**TO:** Planning Commission  
**FROM:** Molly Just, Planning Director  
**ITEM:** Carmelite Hermitage of the Blessed Virgin Mary Conditional Use Permit for Chapel

To: Ben Hetzel, City Planner  
Cc: Molly Just, Planning Director  
Chad Isakson, Assistant City Engineer  
From: Jack Griffin, P.E., City Engineer  
Re: Carmelite Heritage Chapel Site Improvements  
Engineering Site Plan Review

A Site Plan engineering review has been completed for the Carmelite Hermitage Chapel Conditional Use Construction Plan set. The site is located at 8249 DeMontreville Trail North in Lake Elmo. The submittal consisted of the following documentation received on June 14, 2022:

# CARMELITE HERMITAGE CHAPEL

GRADING PLAN

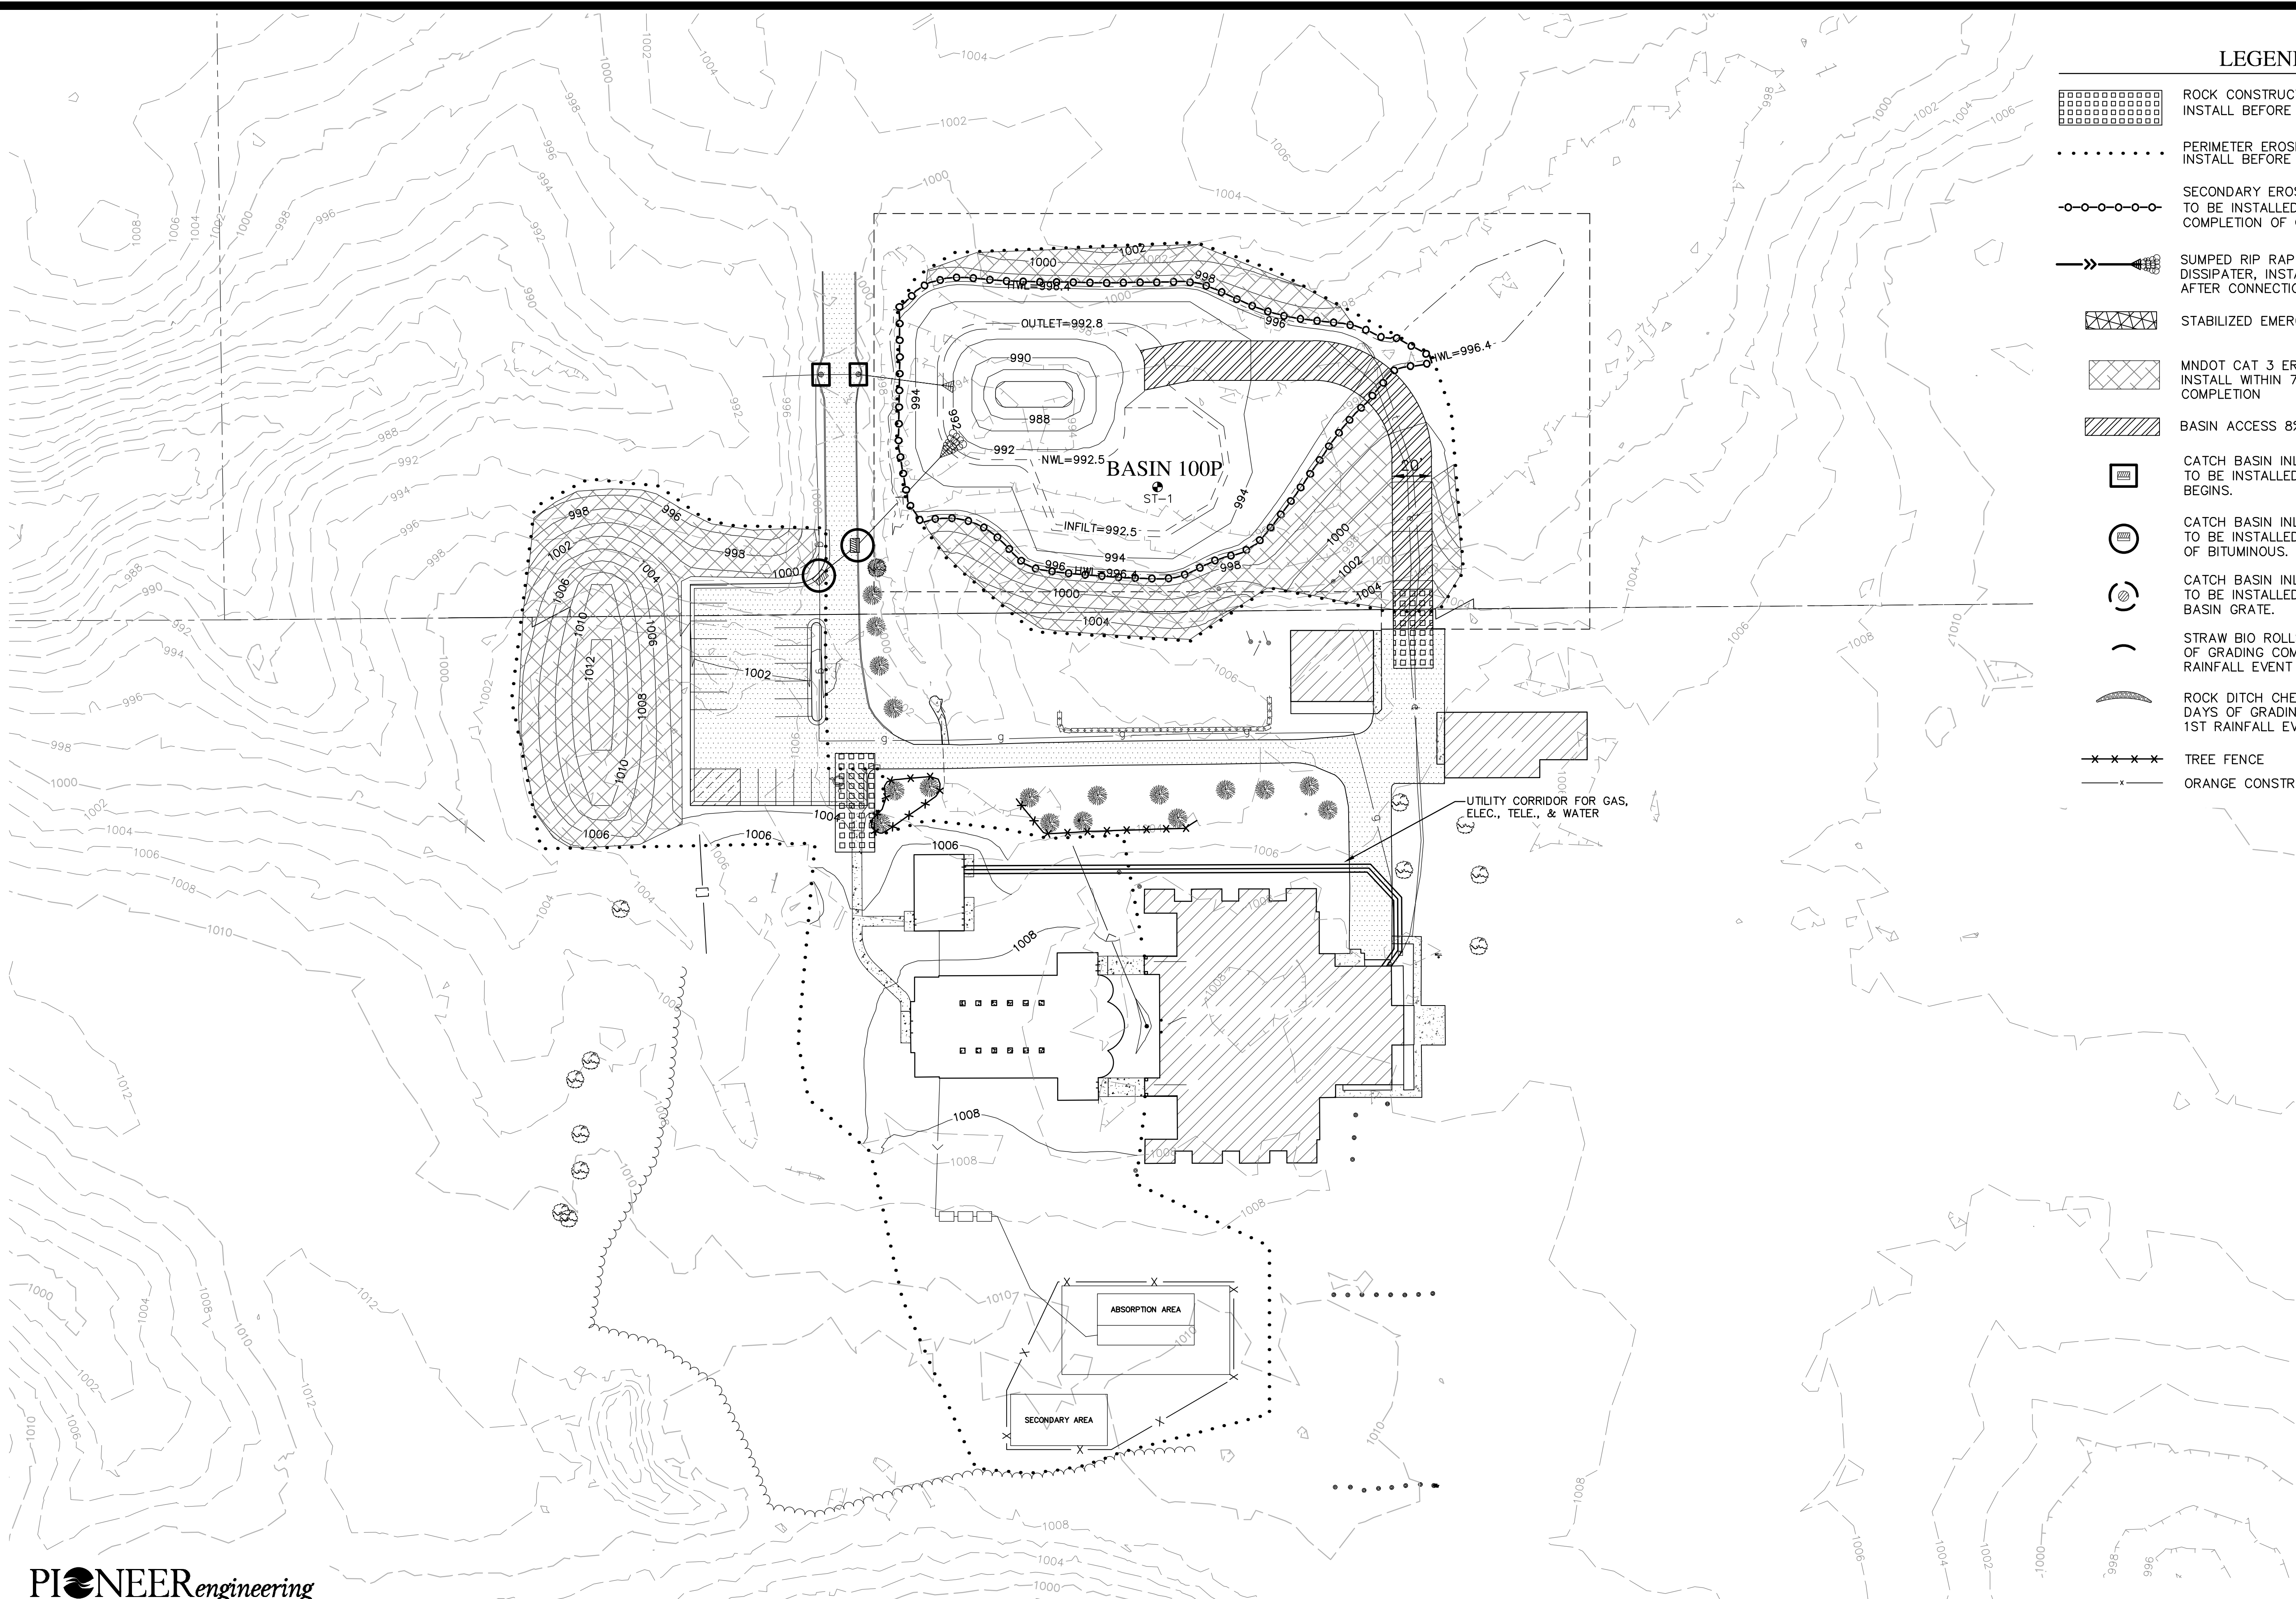
- Sheet 5.10. Revise grading plan to revise storm water BMP site to meet City of Lake Elmo and MN Storm Water Manual standards and as follows:
  - Provide 10:1 aquatic bench and 10:1 maintenance bench around retention BMP. Add typical pond detail cross section to identify required benches.

- Provide defined rip rap overflow location between retention basin and infiltration basin and define overflow spot elevation.
- Sheet 5.10 Provide drainage and utility easement over storm water BMP including the 100-year HWL, emergency EOF pathway, and pond maintenance access road and access bench. Easement area must be clearly shown on the plans.
